**Roof Repair & Replacement Project at  
Boggy Creek & Curriculum Development Annex  
Bid # SDOC-07-098-FPC**

Addendum #1

May 25, 2007

SCALE: N.T.S.  
DATE: 04/25/07  
DWG.#:  
1.1

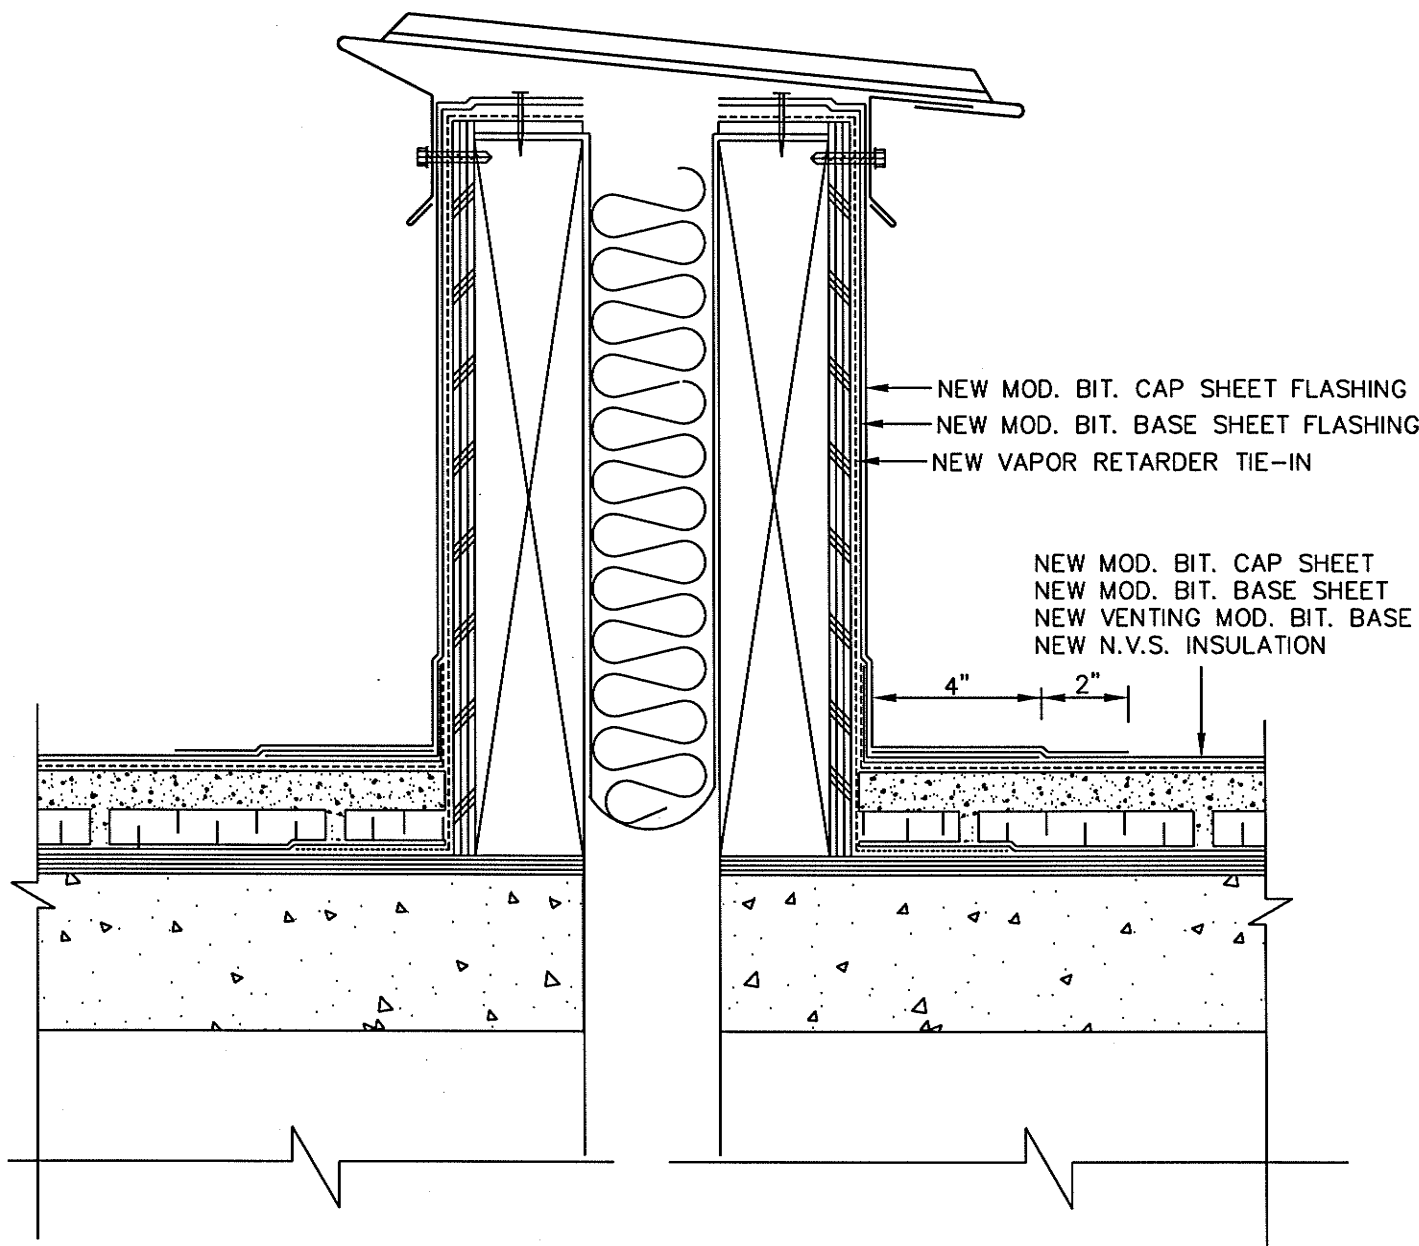
- a. REF Detail #1: The objective of the requirements of this detail is to have additional solid and continuous nailers added to have the new curb edge approximately 2" ( $\pm 1/4$ " ) above the new roof surface. The detail shows an existing condition where the perimeter curb edge is at its highest point. The attached detail # 1.1 clarifies the new edge condition.

NEW COPING SHALL BE A MIN. OF 2" ABOVE ROOF SURFACE.

SCALE: N.T.S.  
 DATE: 04/25/07  
 DWG.#:  
 4.1

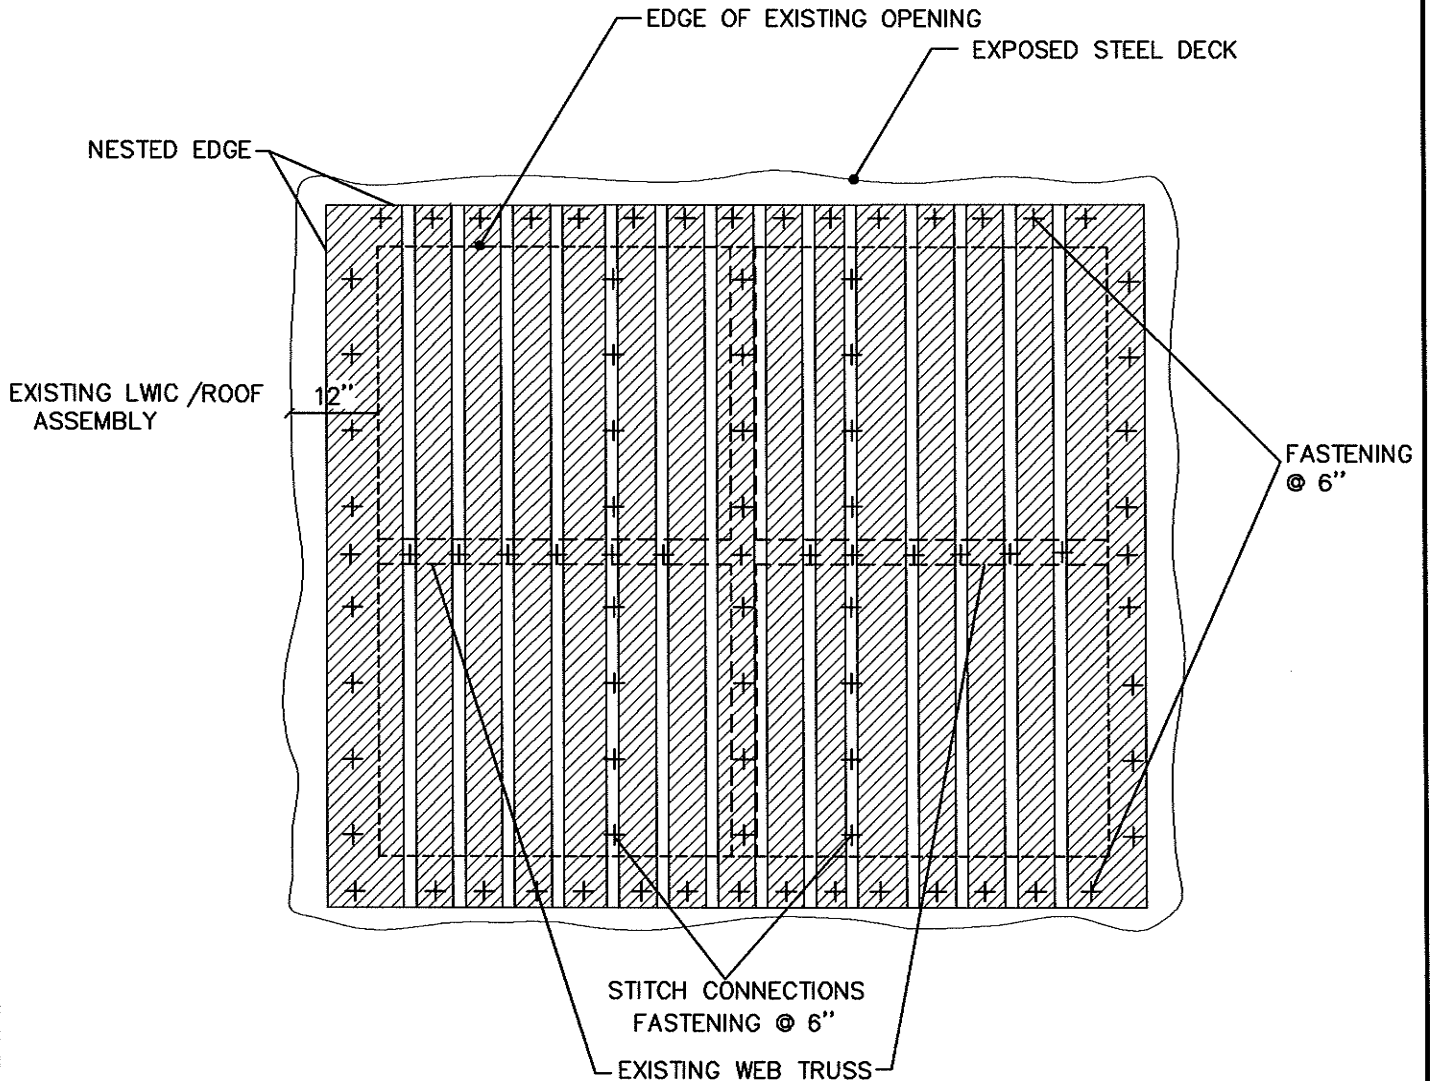
- b. Edge metal shall be factory painted Kynar 24 ga. sheet metal
- 2. REF Detail # 4: Expansion joint shall be constructed as shown in new Detail # 4.1
